CHERRY HILLS VILLAGE
COLORADO

City Council Agenda
Tuesday, June 3, 2014

Should the City Council approve a request by St. Mary's Academy for an Expanded Use Permit to add an approximately 22,722 square-foot multipurpose building to the campus?

COMMUNITY CENTER EXPANDED USE PERMIT

Figure 1
Existing Peak Hour
Entrance/Exit Traffic Volumes

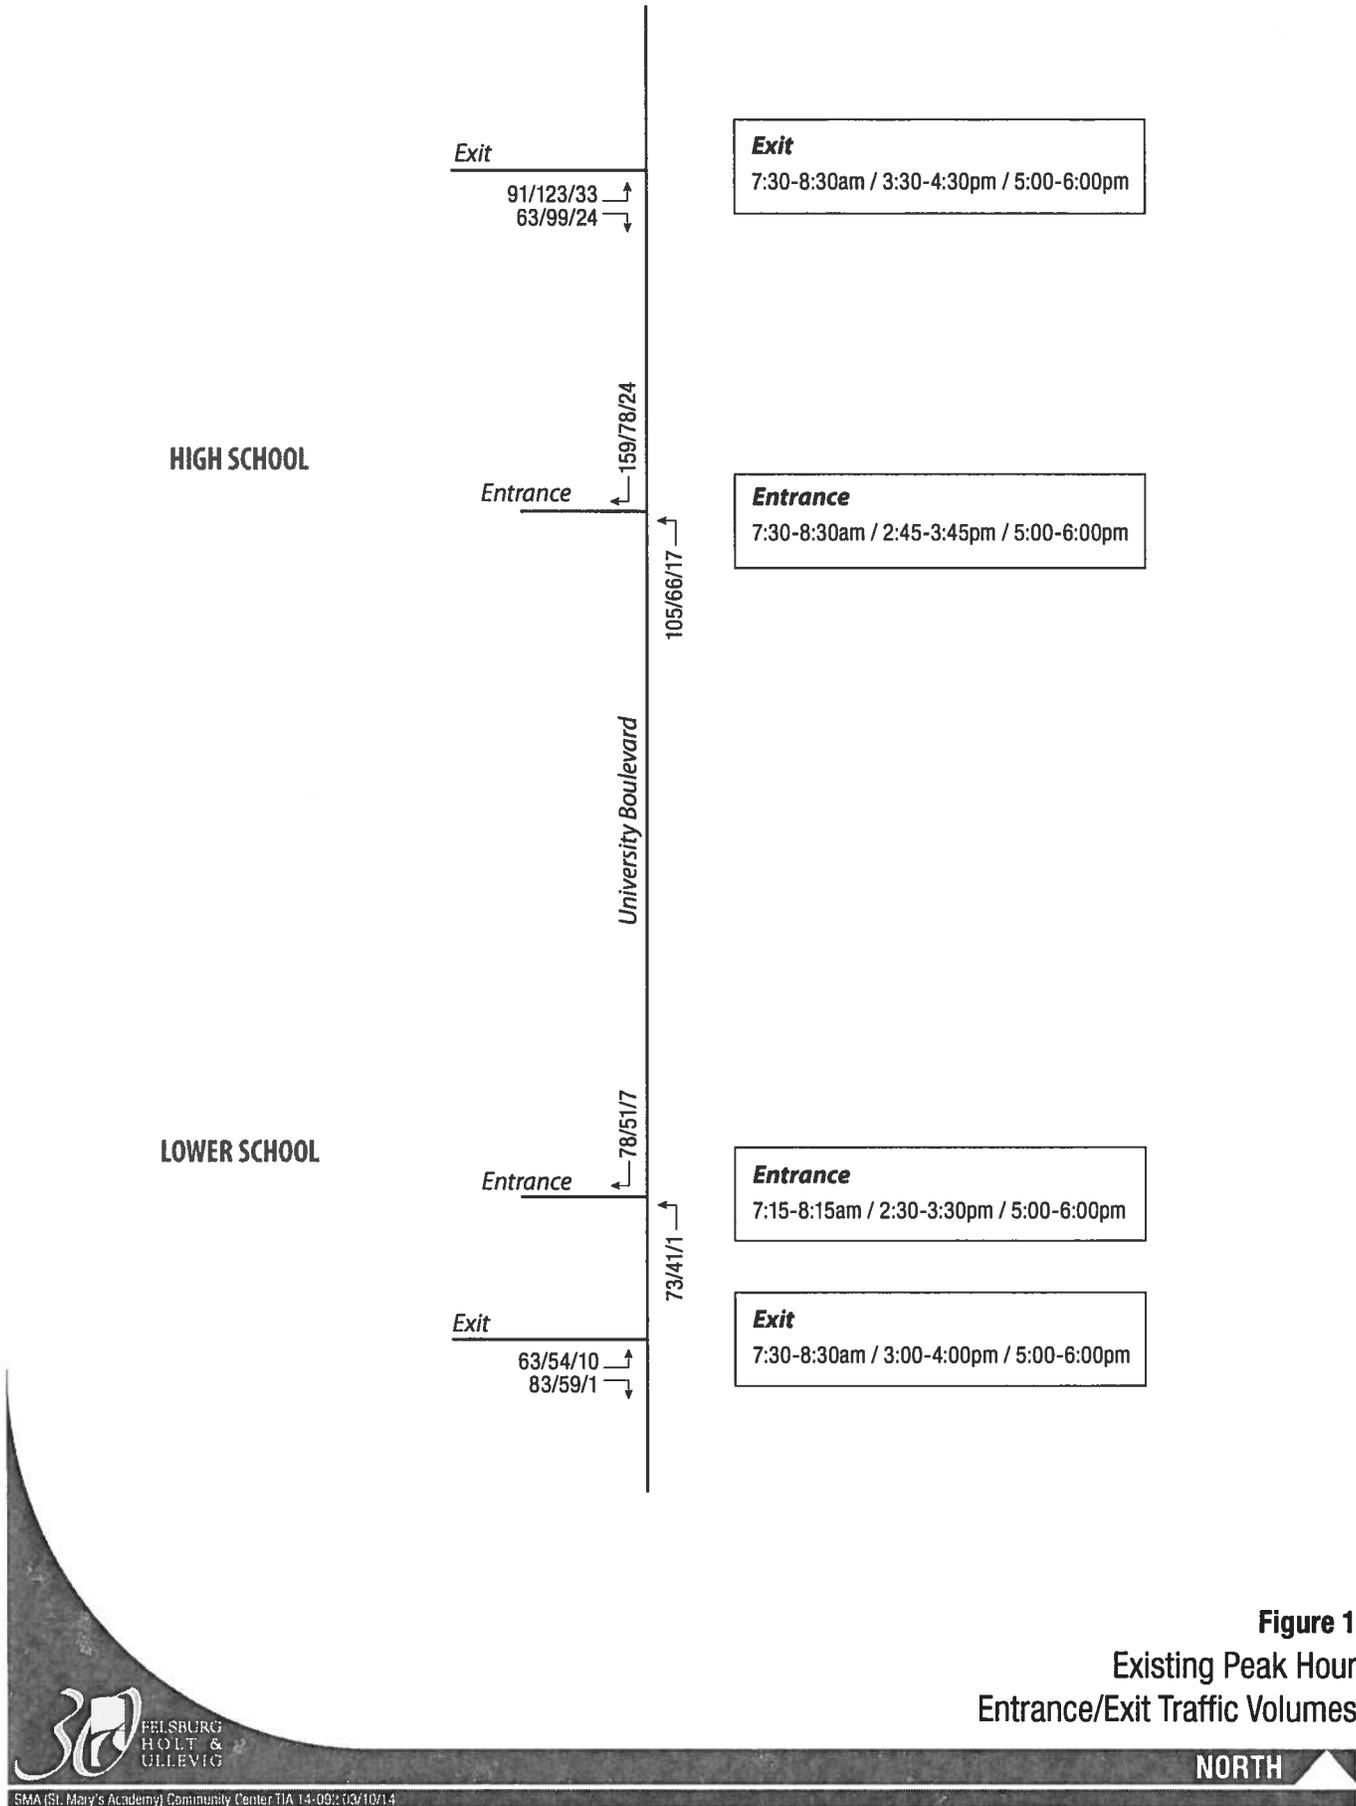
Figure 1 illustrates the turning movement counts recently recorded at each entrance and exit. The volumes depicted on the graphic illustrate the morning peak period, the afternoon peak period, and a period later in the day which reflects traffic associated with after-school activities and coinciding with peak traffic on University Boulevard. Note that these reflect the true peak volumes at each location and the time periods differ for the different locations. Thus, when one combines these volumes (as shown in **Figure 1**), the total reflects a combination of the highest volumes, which will be greater than the volumes in any given hour.

If one compares the volumes shown on **Figure 1** with those of **Figure 3** in the 1999 traffic study, the following findings can be noted:

Site and
Landscape Plan

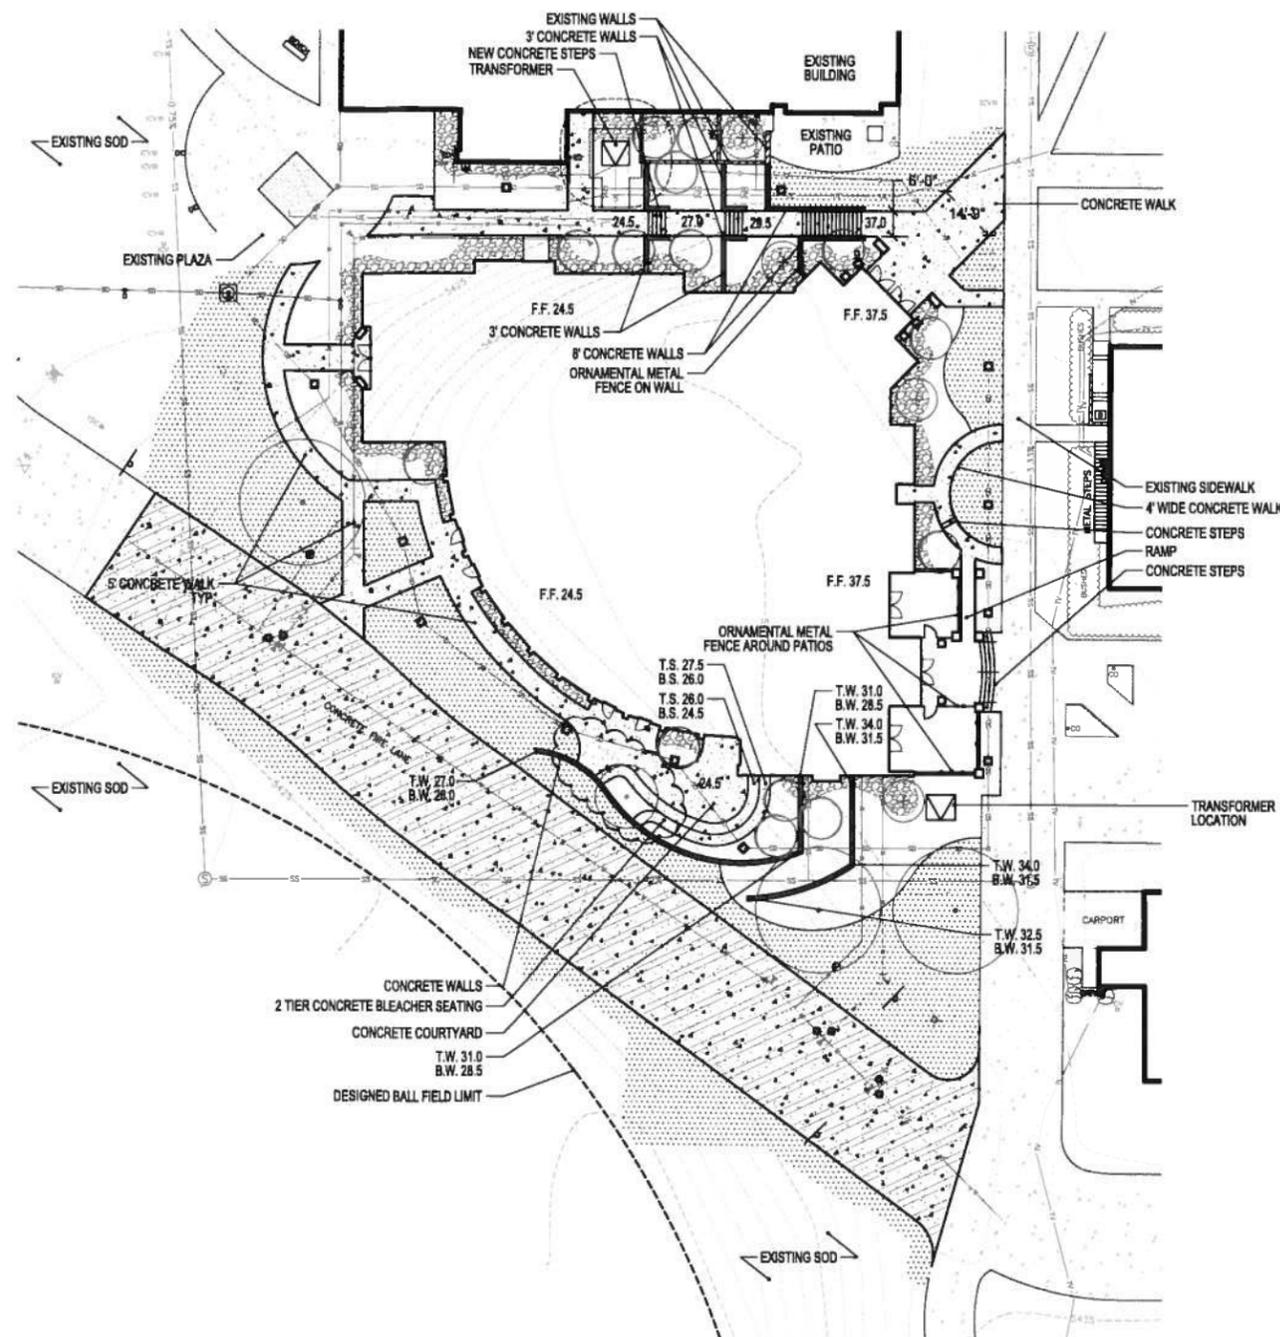
Complete – See Sheet S-2 of Site Plan for walkways and landscaped areas around the proposed addition.

Complete – See Sheet S-2 of Site Plan for illustrative landscape plan. Retaining walls will be installed south of the proposed addition. Surrounding the proposed building are several concrete walkways, turf areas, and planting beds with shrubs and trees.

Sheet Title
**Building Height
Compliance**
Sheet Number

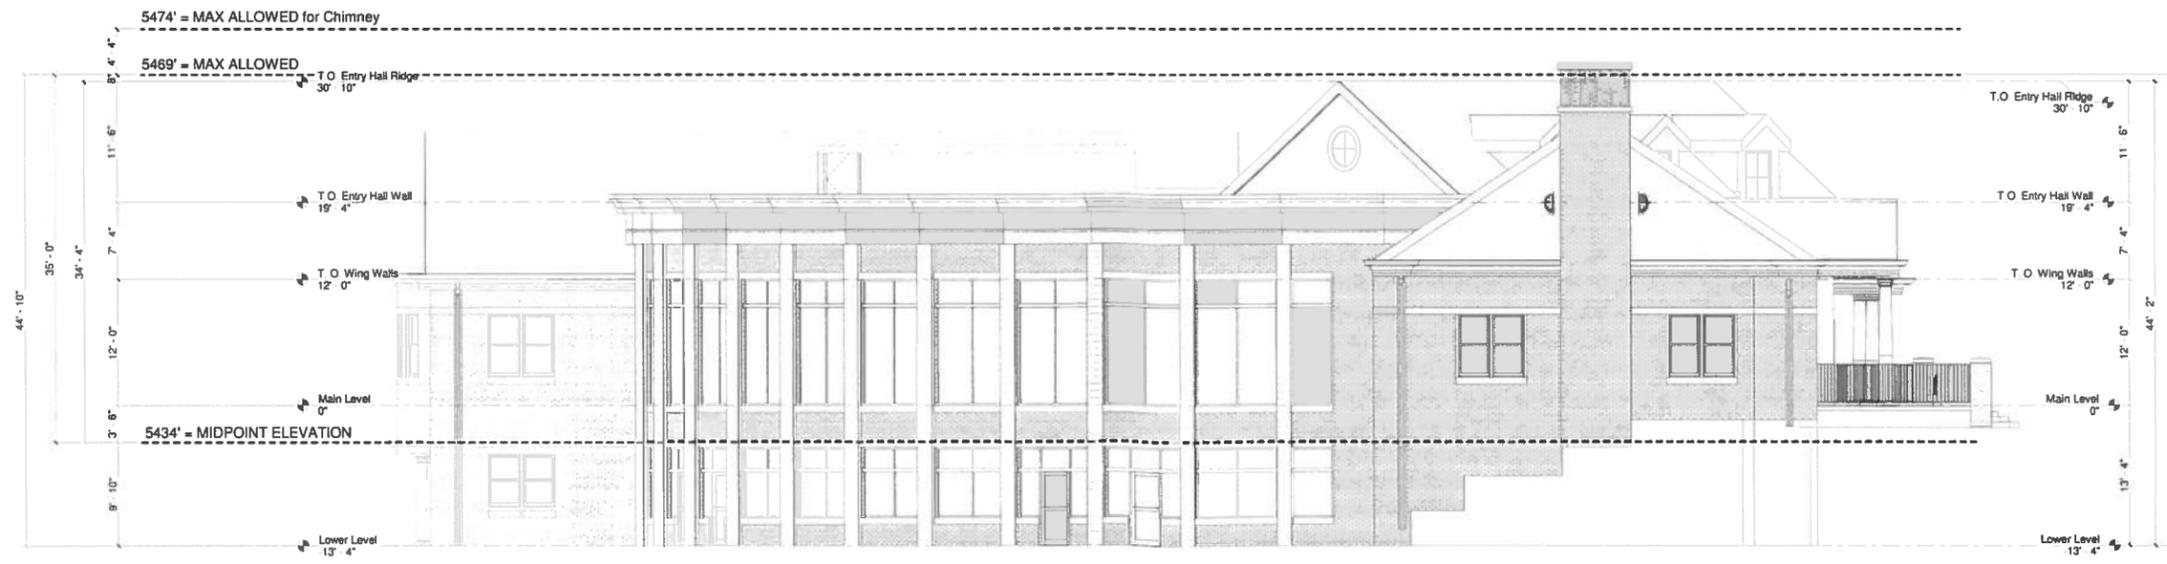
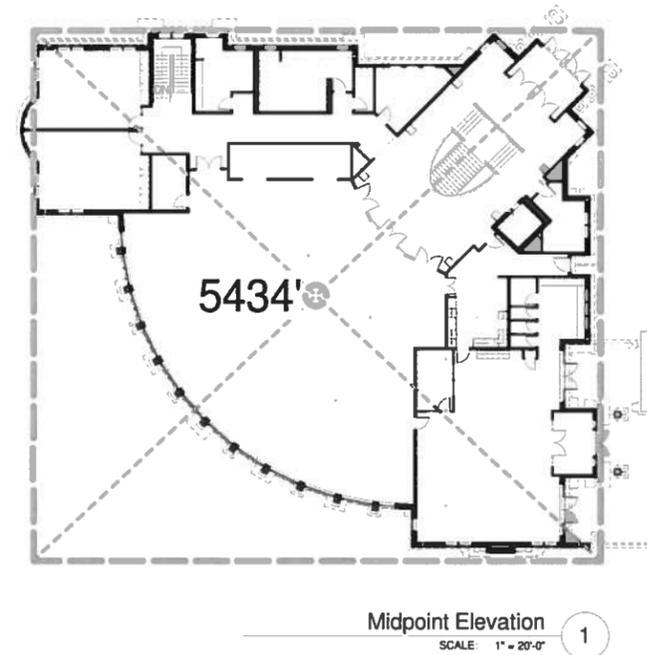
Complete – The existing and proposed floor area and building heights are provided on Plan Sheet S-0. The allowed and proposed height of the addition is calculated on Plan Sheet S-3 and includes a proposed height of 34 feet and 4 inches above the center point grade of the structure:

Maximum building height for principal and accessory structures is measured from the natural grade at the midpoint of the structure to the highest point of the finished roof surface.

**MIDPOINT ELEVATION IS 5434' + 35' =
ALLOWED MAXIMUM ELEVATION OF 5469'**

MAX = 5434 + 35 = **5469**
PROPOSED = 5434 + 34'- 4" = **5468' - 4"**

Lighting Plan

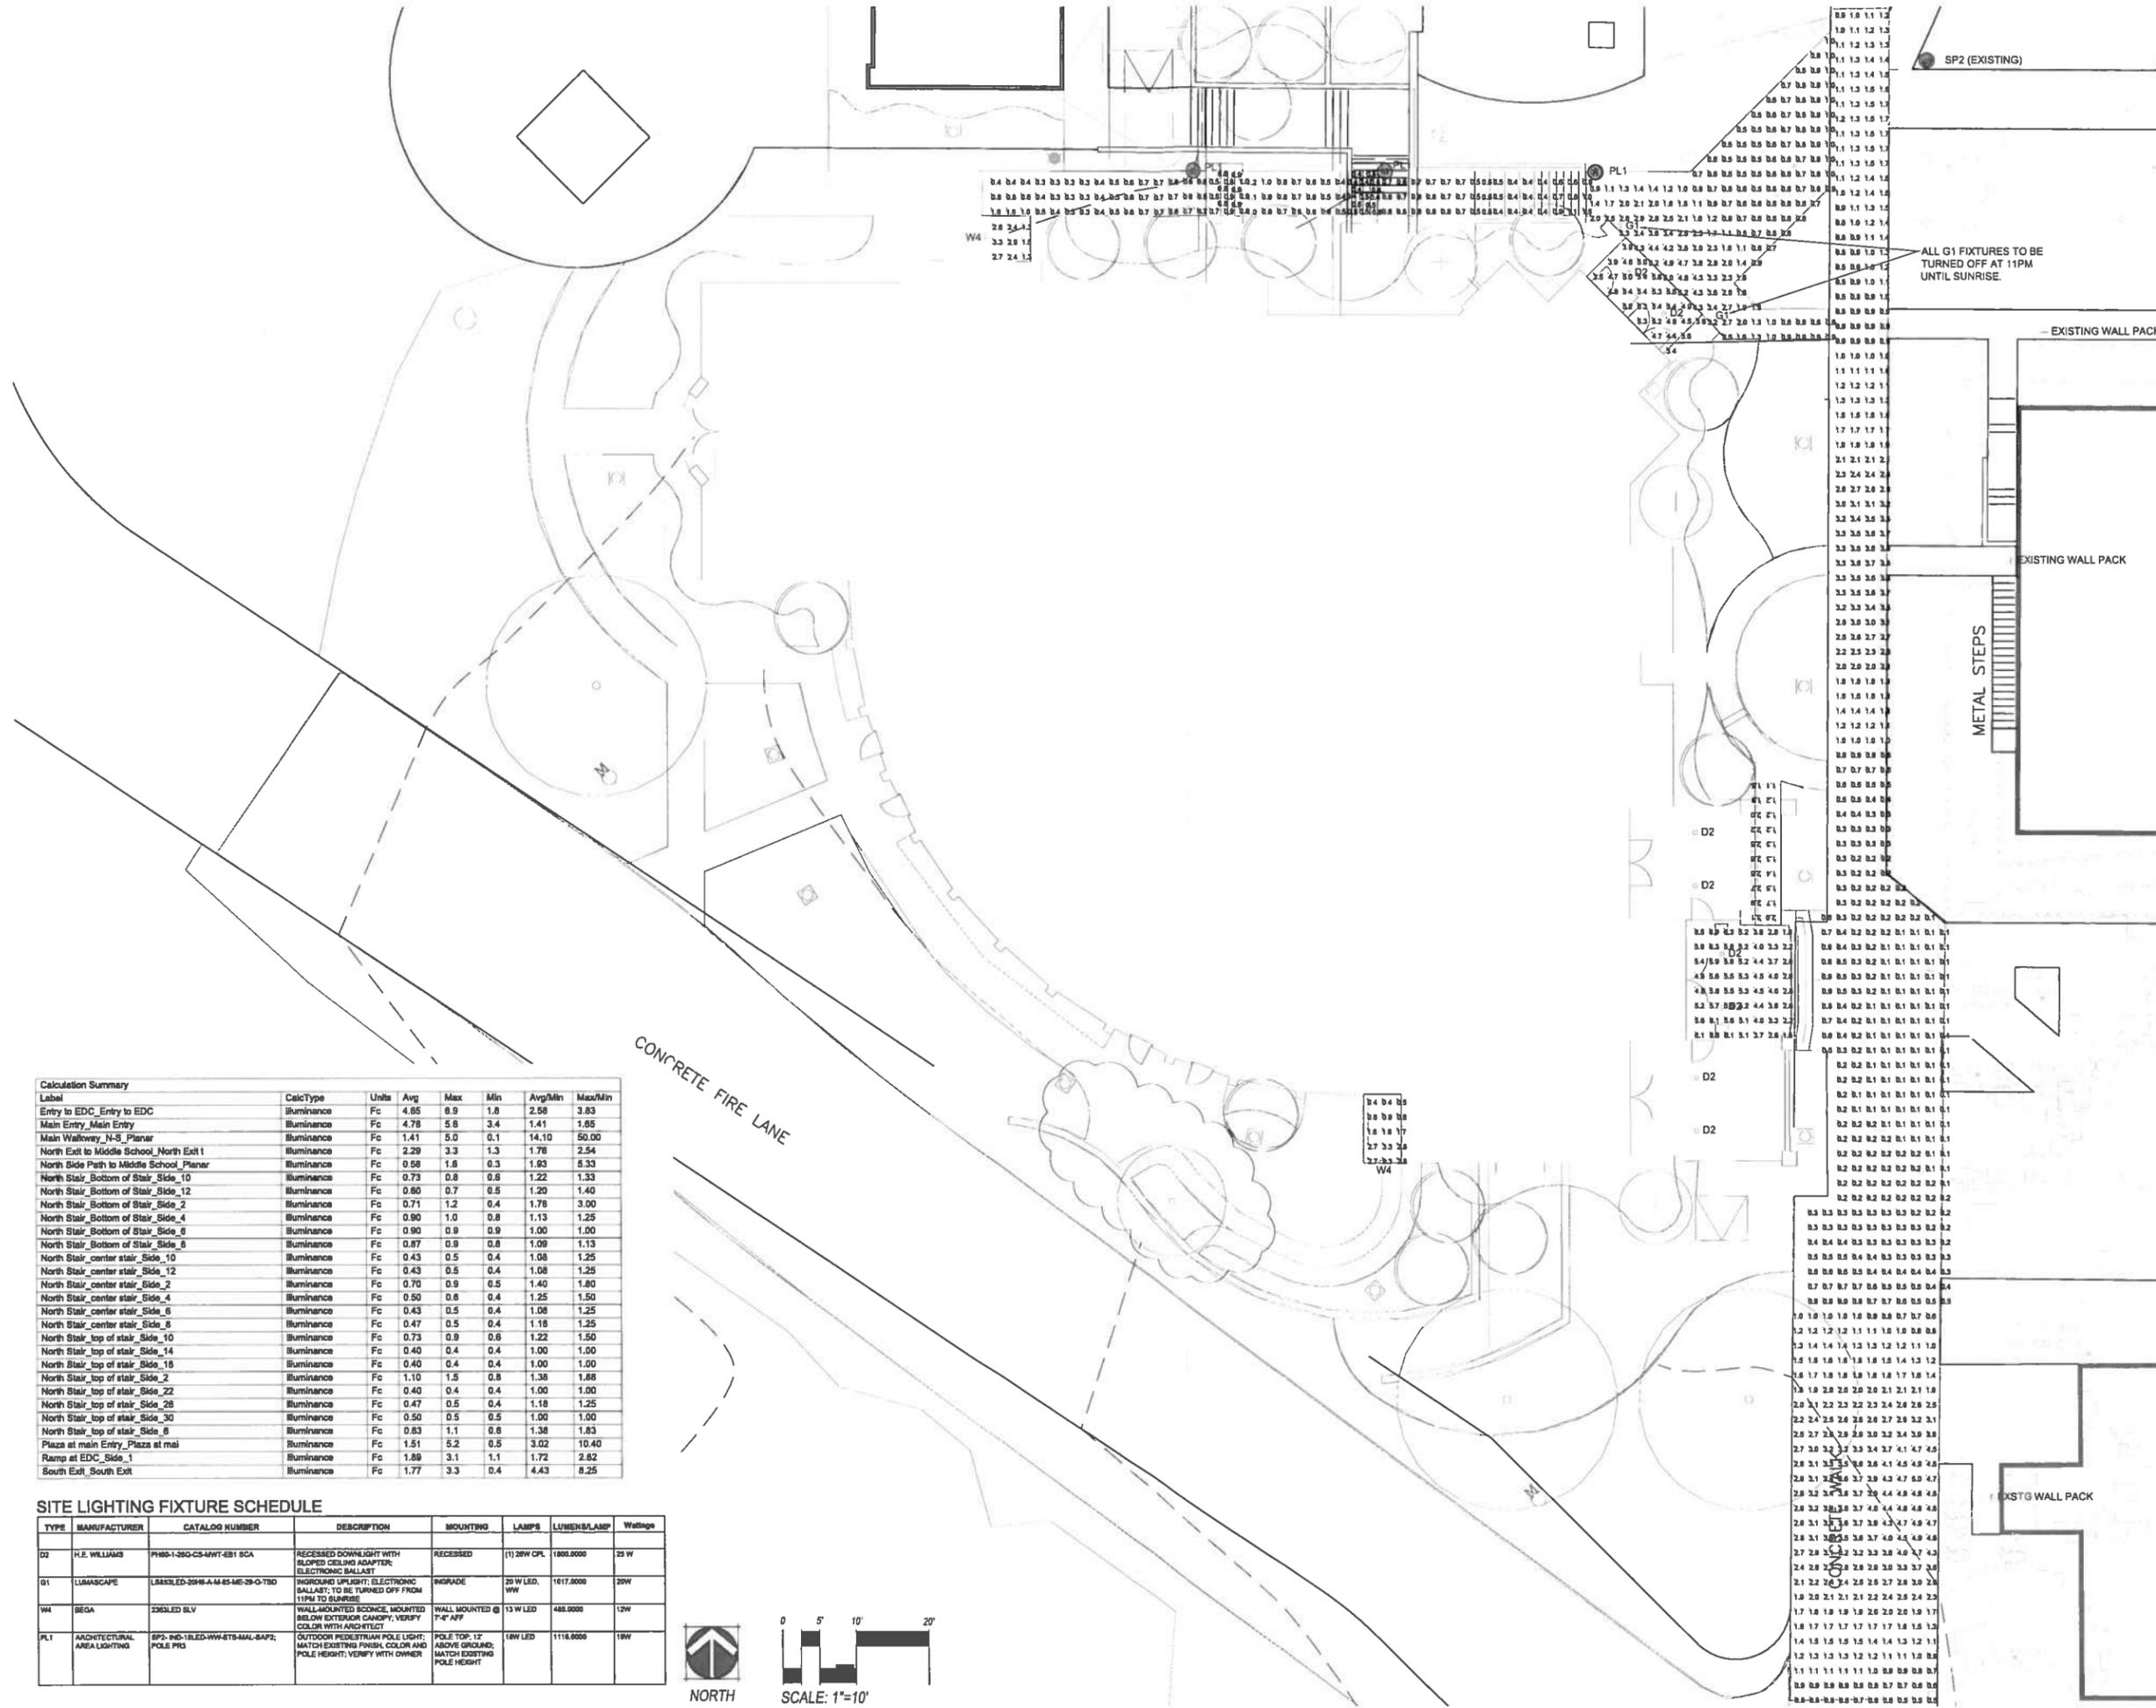
Complete – The location, fixture details and photometric light levels of the proposed exterior lighting are provided on Plan Sheet S-7. The fixtures meet the City's current standards for full-cutoff fixtures, maximum lumen output and maximum light level at adjoining property lines.
